Access Compliance Report Public Rights-of-Way (Curb Ramps)

Main Street: MONTE_VISTA_AVE Cross Street: IRVINE_AVE Location: N

ADA ID: RPRK211018124450 Ramp Type: Type 4 - Parallel Initial Pass/Fail: Pass Overall Compliance: No Severity Score: 6

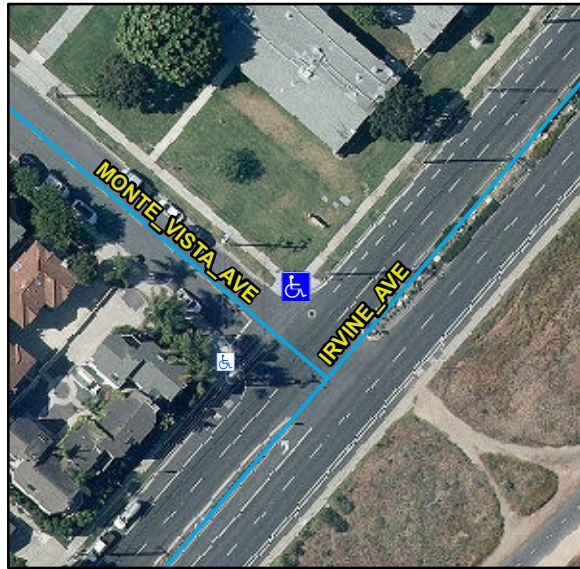
R304.2.2, R204.3, R304.5.4, STD 1115

Crossing 1 Slope (%)	7.3		Crossing 2 Slope (%)	2.4
	Crossing 1 Cross Slope (%)	0.6		Crossing 2 Cross Slope (%)	3.1
Yes	Gutter Ponding	No	No	Curb Slope	14.8
Yes	Gutter Lip Height (in)	0		Road Run Slope (%)	1.4
No	Gutter Run Slope (%)	8.4		Road Cross Slope (%)	4.1
Yes	Gutter Cross Slope (%)	0.5	No	Perpendicular Joint Present	No
Yes	Overall Surface Condition	Acceptable			
	Cross Gutter Present?	No		Spandrel Present?	No
	Replace Cross Gutter?	N/A		Replace Spandrel?	N/A

Remove & Replace Curb Ramp With Two New Directional Ramps or Equivalent. Remove & Replace Gutter.
